68-74 DEEPWATER ROAD CASTLE COVE

DEVELOPMENT APPLICATION FOR THE CASTLE COVE COUNTRY CLUB AND 17 INDEPENDENT LIVING UNITS

Responses to Council's RFI #2 :

DRAWING NO.
DA 3.03
SCALE
As indicated
0m 2 4 5m
Scale 1:250

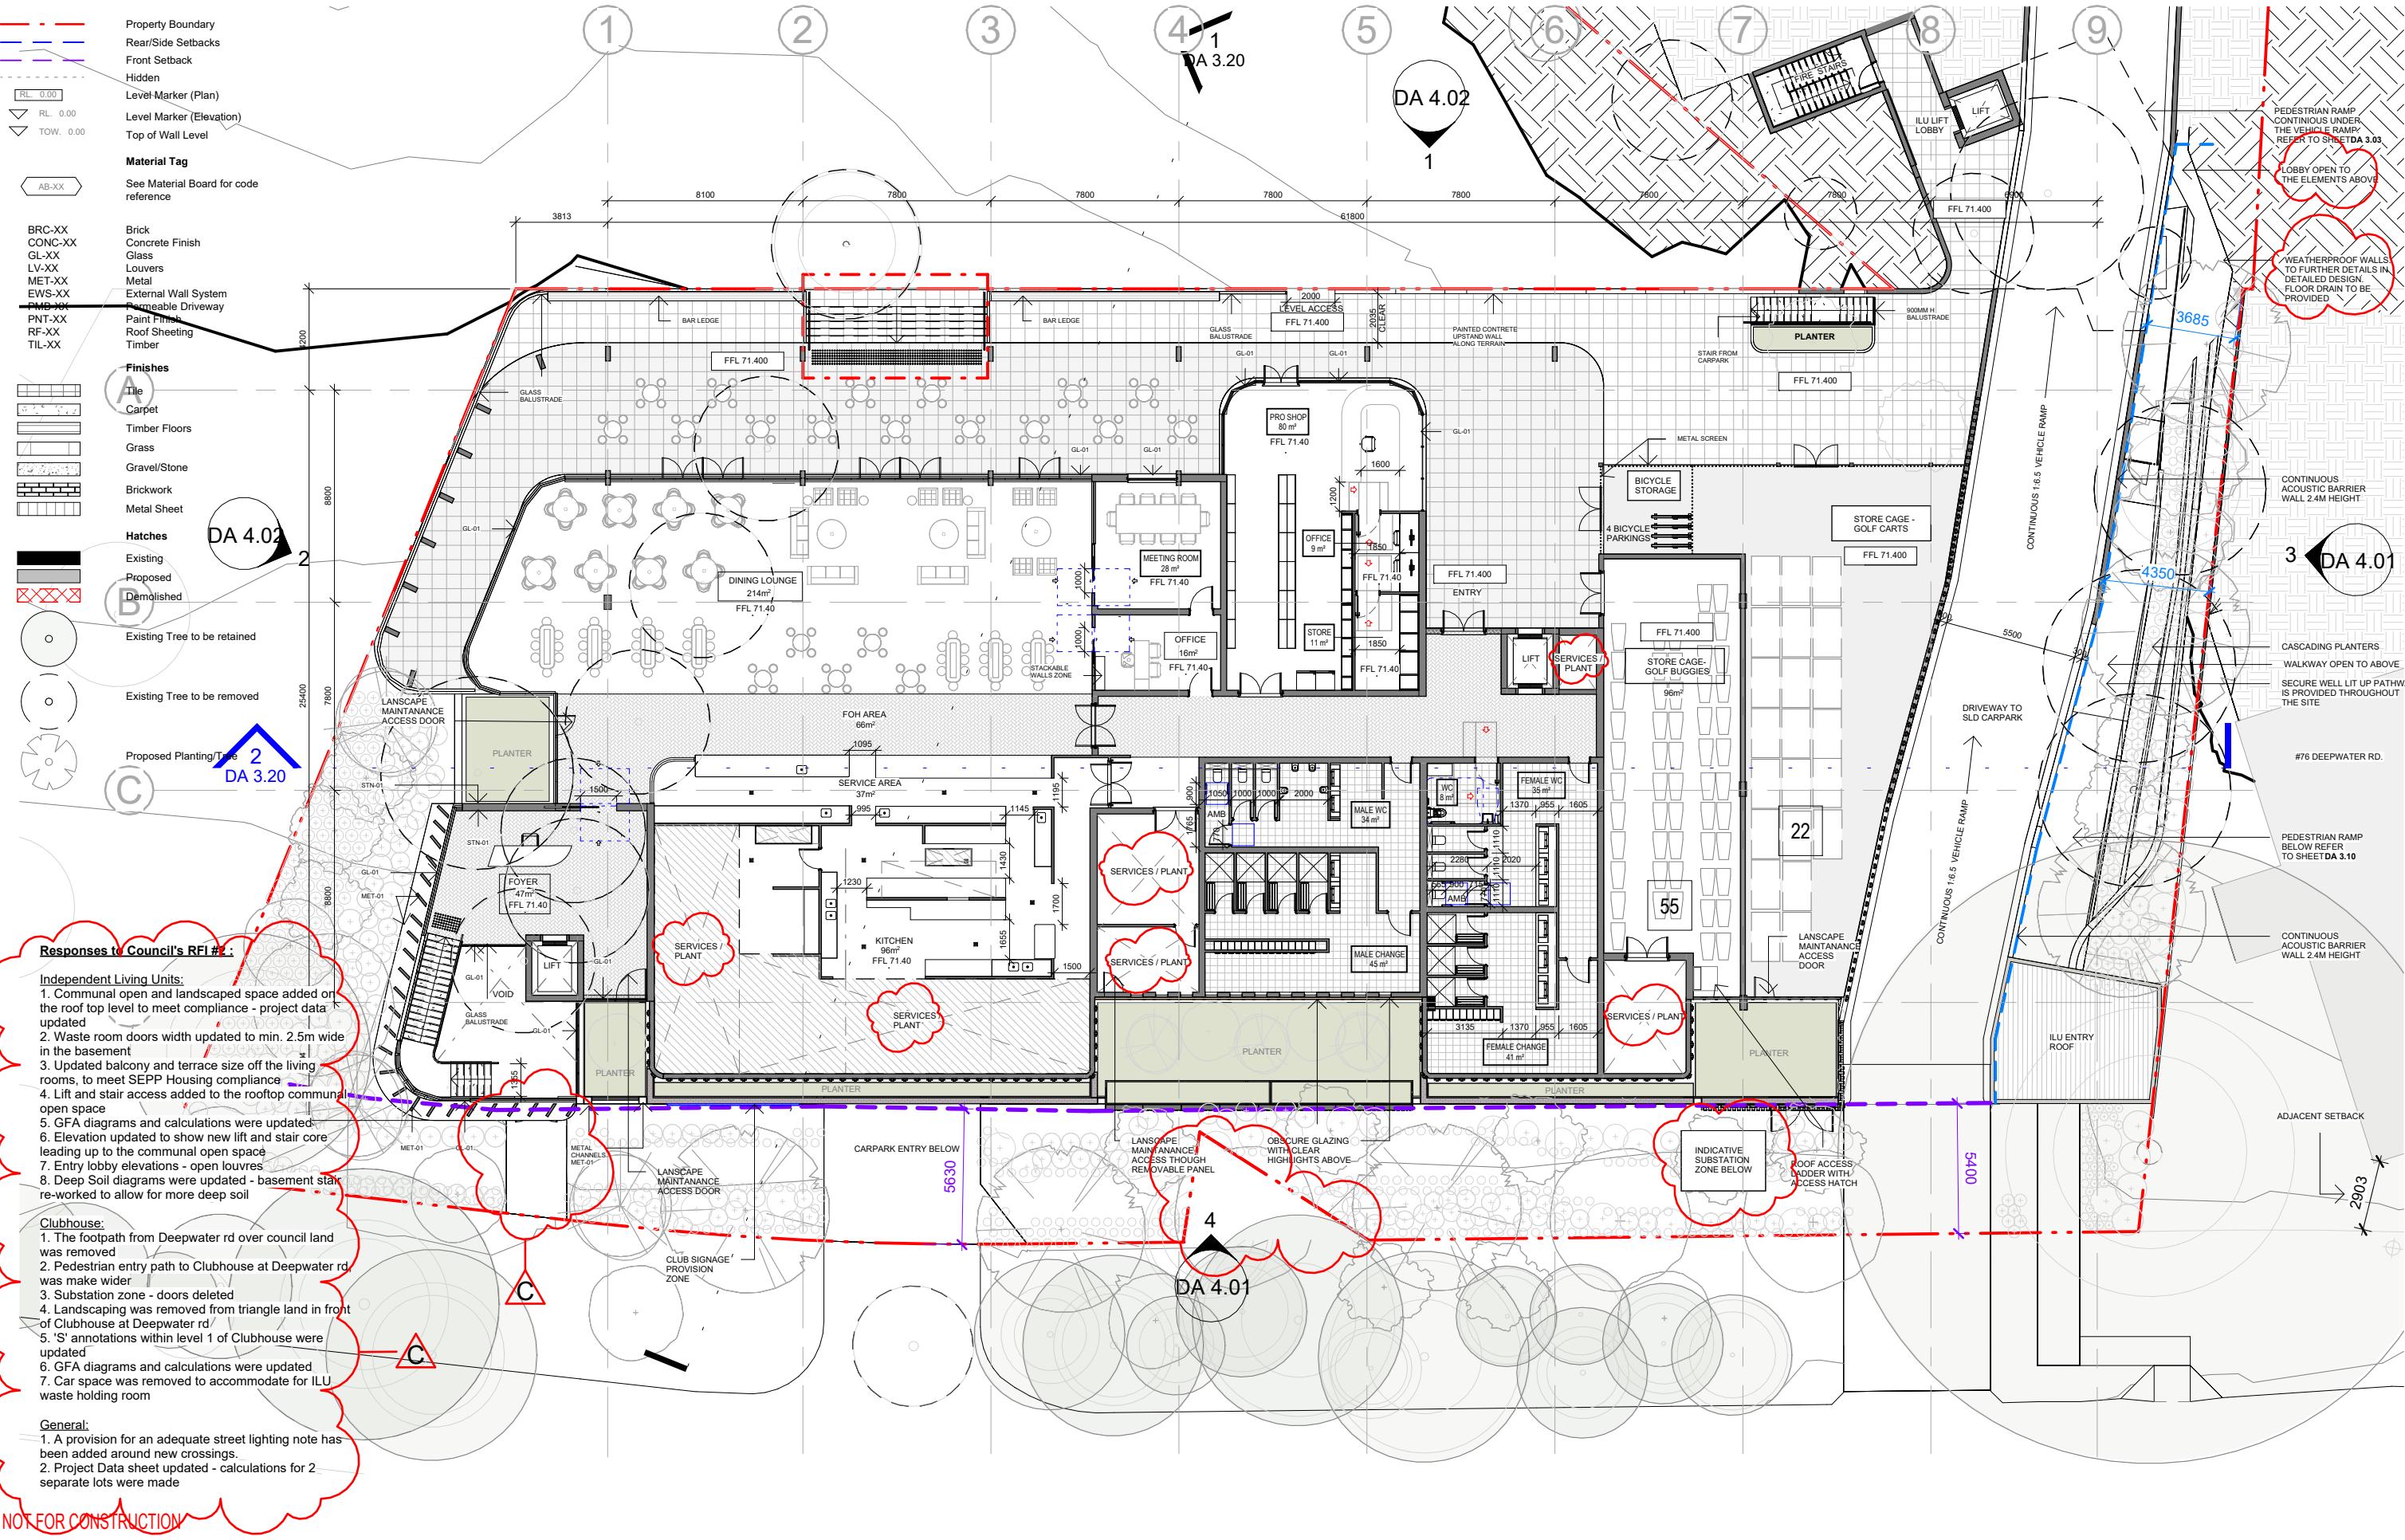
Responses to Council's RF1 #2:

- Independent Living Units:
1. Communal open and landscaped space added on the roof top level to meet compliance - project data updated
2. Waste room doors width updated to min. 2.5m wide in the basement
3. Updated balcony and terrace size off the living rooms, to meet SEPP Housing compliance
4. Lift and stair access added to the rooftop communal open space
5. GFA diagrams and calculations were updated
6. Elevation updated to show new lift and stair core leading up to the communal open space
7. Entry lobby elevations - open louvers
8. Deep Soil diagrams were updated - basement stairs re-worked to allow for more deep soil

1. The footpath from Deepwater rd over council land was removed
2. Pedestrian entry path to Clubhouse at Deepwater rd was made wider
3. Substation zone - doors deleted
4. Landscaping was removed from triangle land in front of Clubhouse at Deepwater rd
5. 'S' annotations within level 1 of Clubhouse were updated
6. GFA diagrams and calculations were updated
7. Car space was removed to accommodate for ILU waste holding room

1. A provision for an adequate street lighting note has been added around new crossings.
2. Project Data sheet updated - calculations for 2 separate lots were made

DRAWING NO.
DA 5.03
SCALE
As indicated
0m 2.5 5.0 7m
Scale 1:350
REVISION
C
DRAWN BY
MS
CHECKED BY
AA

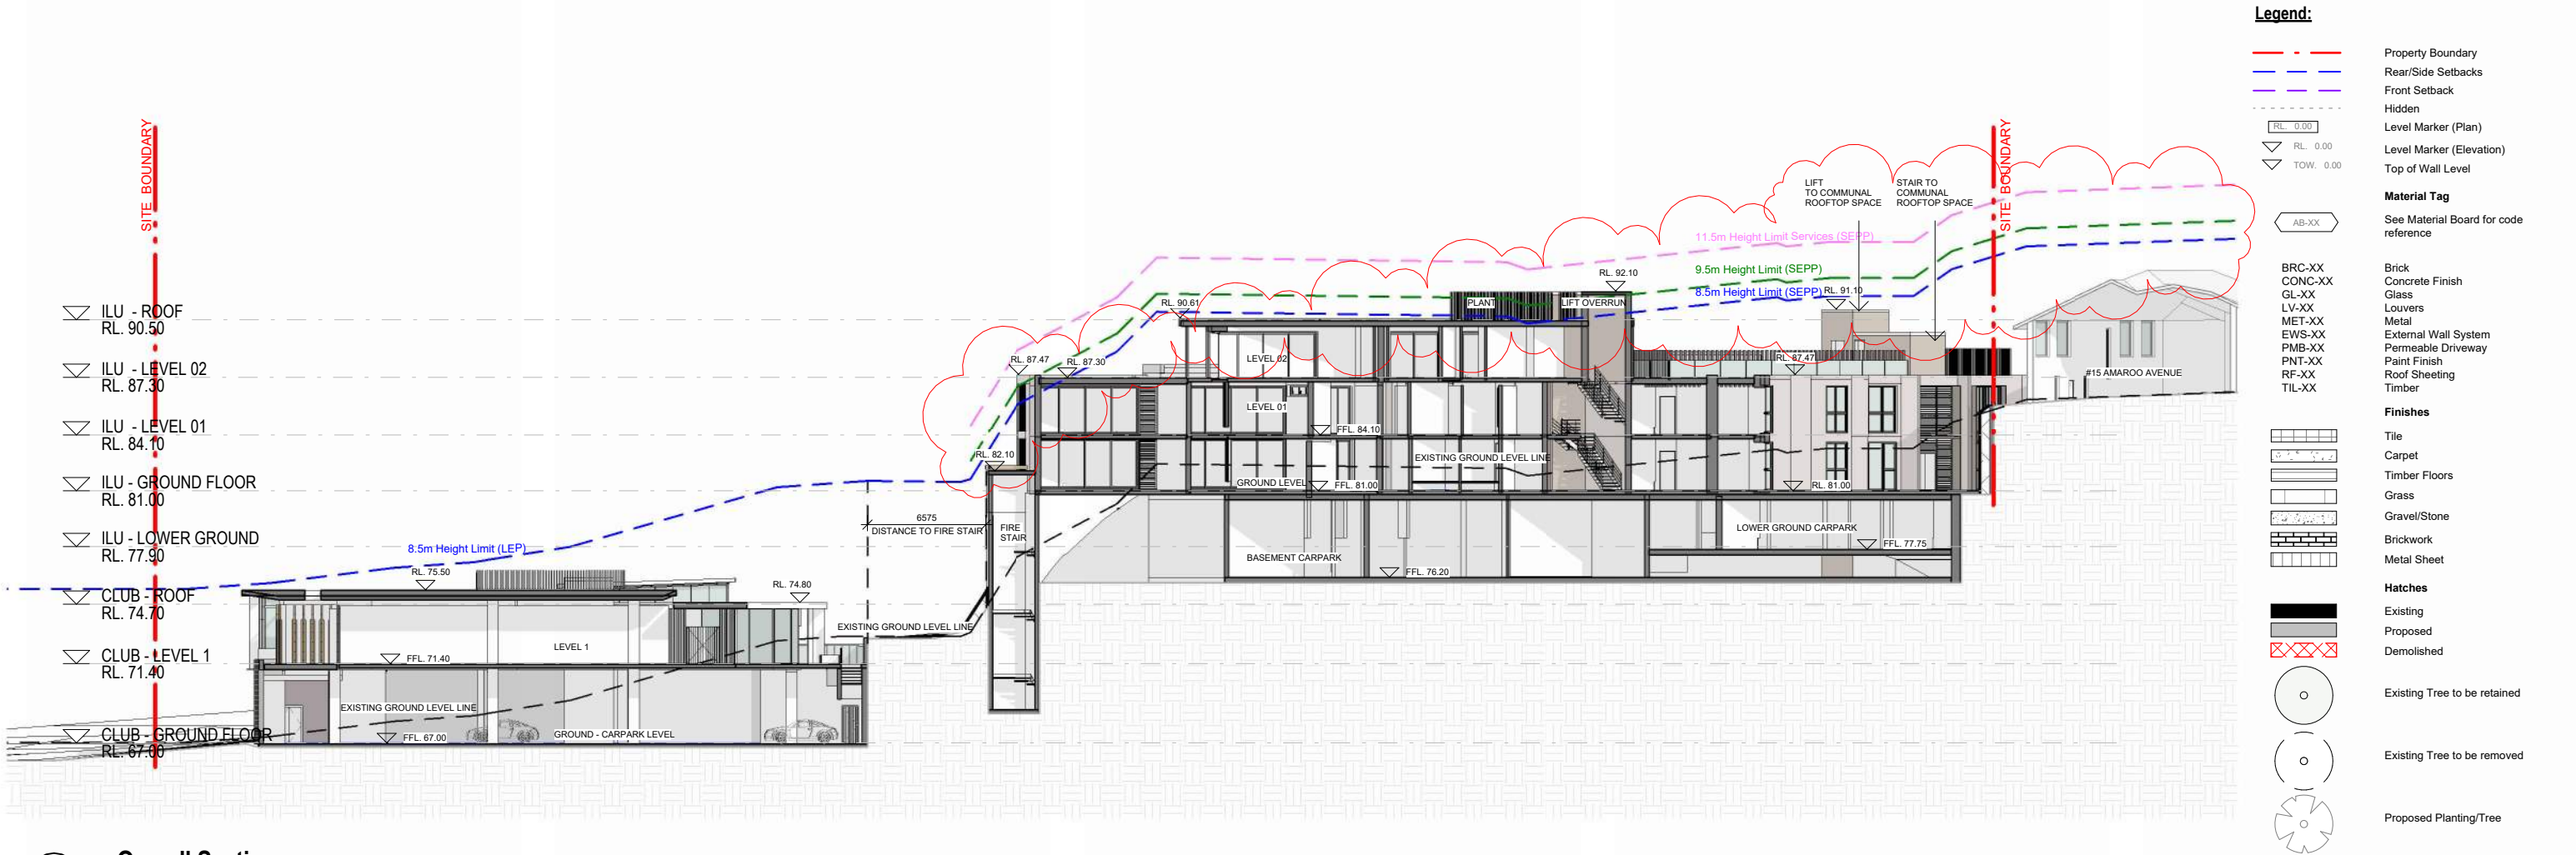
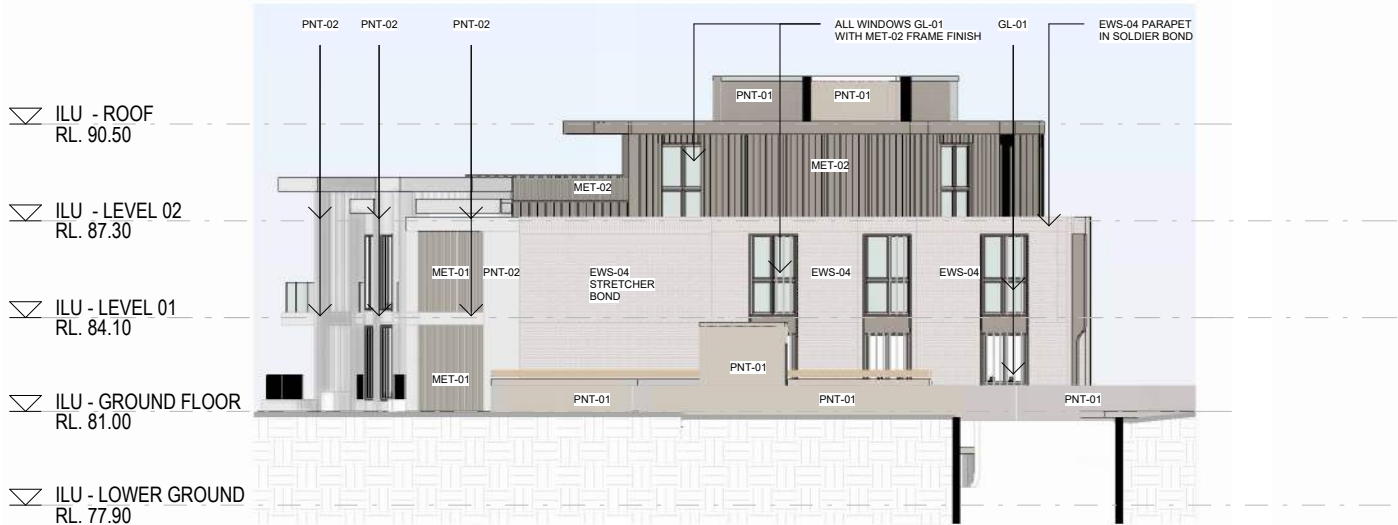
- Responses to Council's RFI #2 :**
- Independent Living Units:**
1. Communal open and landscaped space added on the roof top level to meet compliance - project data updated

4. Lift and stair access added to the rooftop communal open space
 5. GFA diagrams and calculations were updated
 6. Elevation updated to show new lift and stair core leading up to the communal open space

- General:**
1. A provision for an adequate street lighting note has been added around new crossings.
 2. Project Data sheet updated - calculations for 2 separate lots were made

DRAWING NO.
DA 6.06
SCALE
NTS

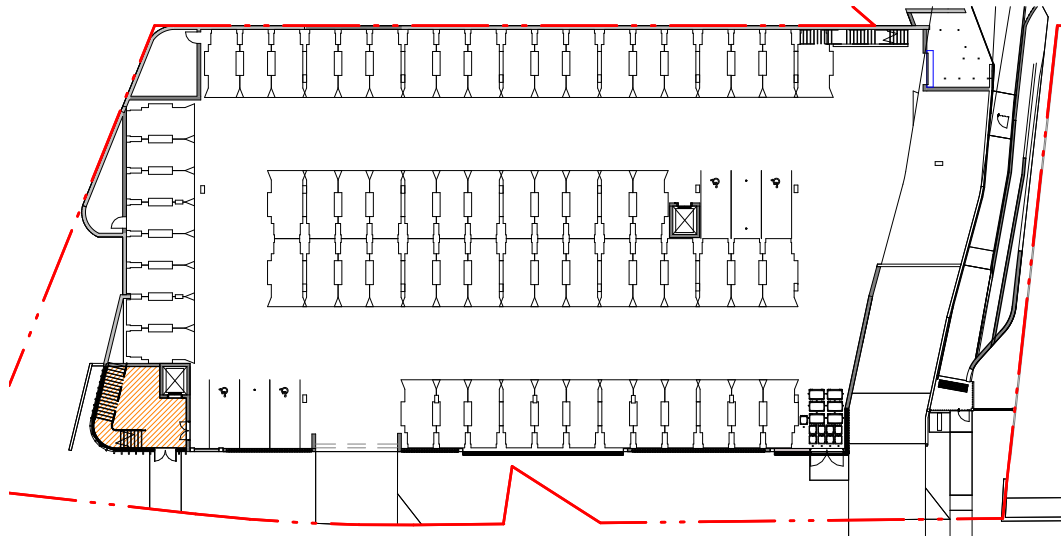
Responses to Council's RFI #2 :

- Independent Living Units:**
- 1. Communal open and landscaped space added on the roof top level to meet compliance - project data updated
 - 2. Waste room doors width updated to min. 2.5m wide in the basement
 - 3. Updated balcony and terrace sizes off the living rooms, to meet SEPP Housing compliance
 - 4. Lift and stair access added to the rooftop communal open space
 - 5. GFA diagrams and calculations were updated
 - 6. Elevation updated to show new lift and stair core leading up to the communal open space
 - 7. Entry lobby elevations - open louvres
 - 8. Deep Soil diagrams updated - basement carpark stair re-worked to allow for more deep soil

- General:**
- 1. A provision for an adequate street lighting note has been added around new crossings.
 - 2. Project Data sheet updated - calculations for 2 separate lots were made
 - 3. Line of 8.5m LEP height limit shown over ILU

GFA	ILU
Lower Ground	173.4 m ²
Ground	1101.23 m ²
Level 1	1076.2 m ²
Level 2	271.3m ²

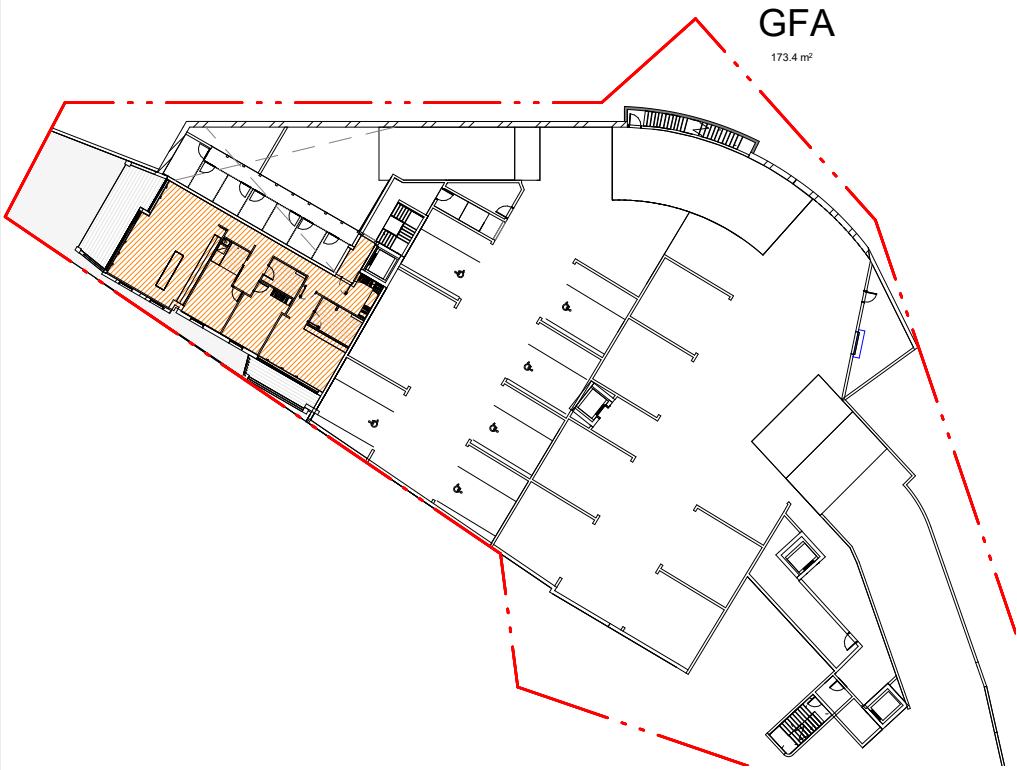
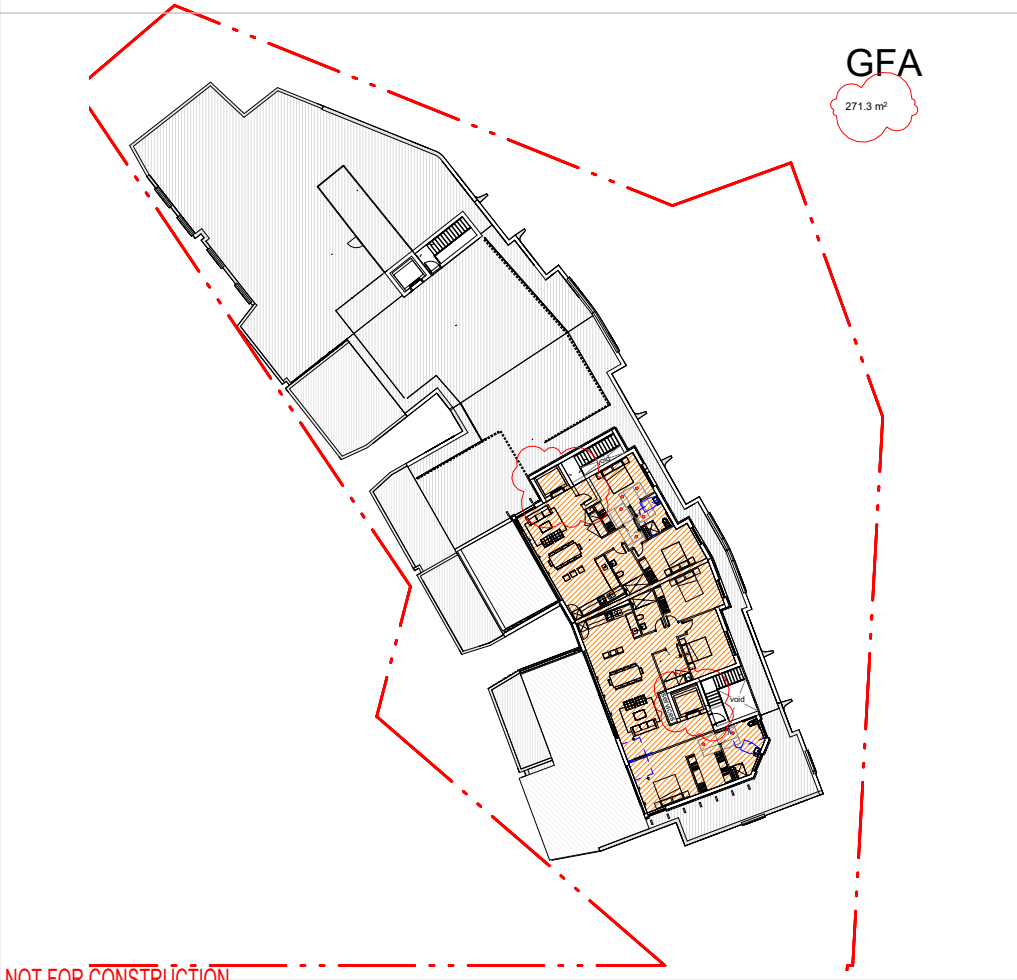
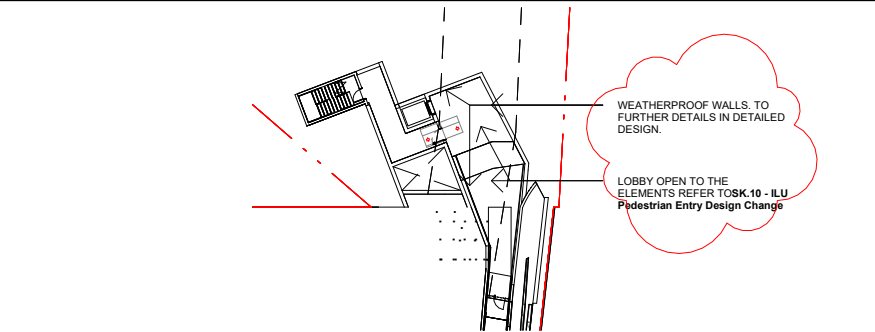
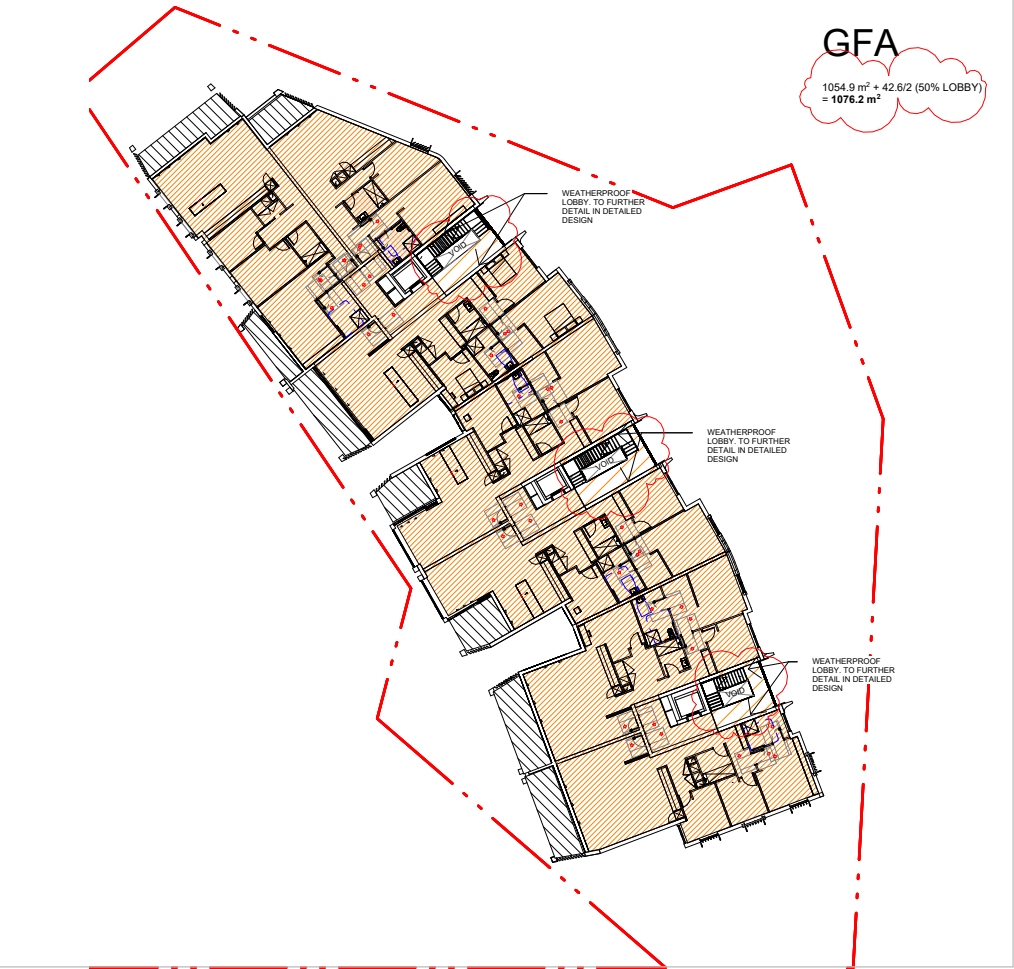
Responses to Council's RFI #2 :

1. Communal open and landscaped space added on the roof top level to meet compliance - project data updated
2. Waste room doors width updated to min. 2.5m wide in the basement
3. Updated balcony and terrace sizes off the living rooms, to meet SEPP Housing compliance
4. Lift and stair access added to the rooftop communal open space
5. GFA diagrams and calculations were updated
6. Elevation updated to show new lift and stair core leading up to the communal open space
7. Entry lobby elevations - open louvres
8. Deep Soil diagrams updated - basement carpark stair re-worked to allow for more deep soil

1. A provision for an adequate street lighting note has been added around new crossings.
2. Project Data sheet updated - calculations for 2 separate lots were made
